SUBJECT: **NEW VEHICLE DEMONSTRATION / DELIVERY HOLD**
Compliance Recall 22C22 - Supplement #5
Certain 2022 Model Year Bronco Sport and F-150 Vehicles
Front Park Lamp Flicker

REF: **NEW VEHICLE DEMONSTRATION / DELIVERY HOLD**
Compliance Recall 22C22 - Supplement #4
Dated: March 18, 2025

New! REASON FOR THIS SUPPLEMENT

FIGURE 1

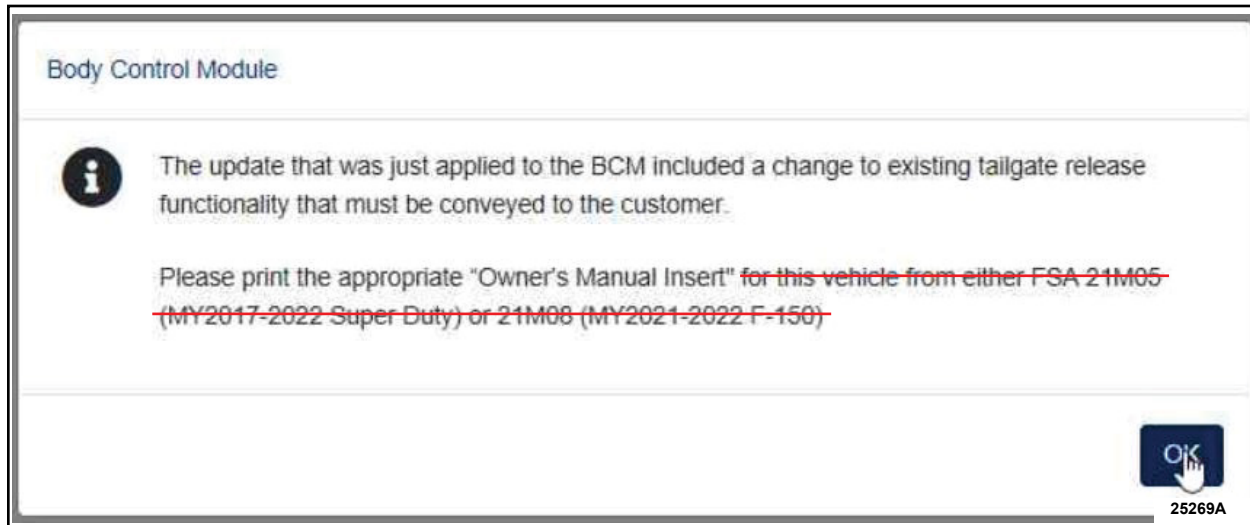
(Do **NOT** print the 21M08 addendum as called out in the FDRS pop-up as shown in Figure 1.)

• Print 22C22-specific Owner's Manual Addendum.
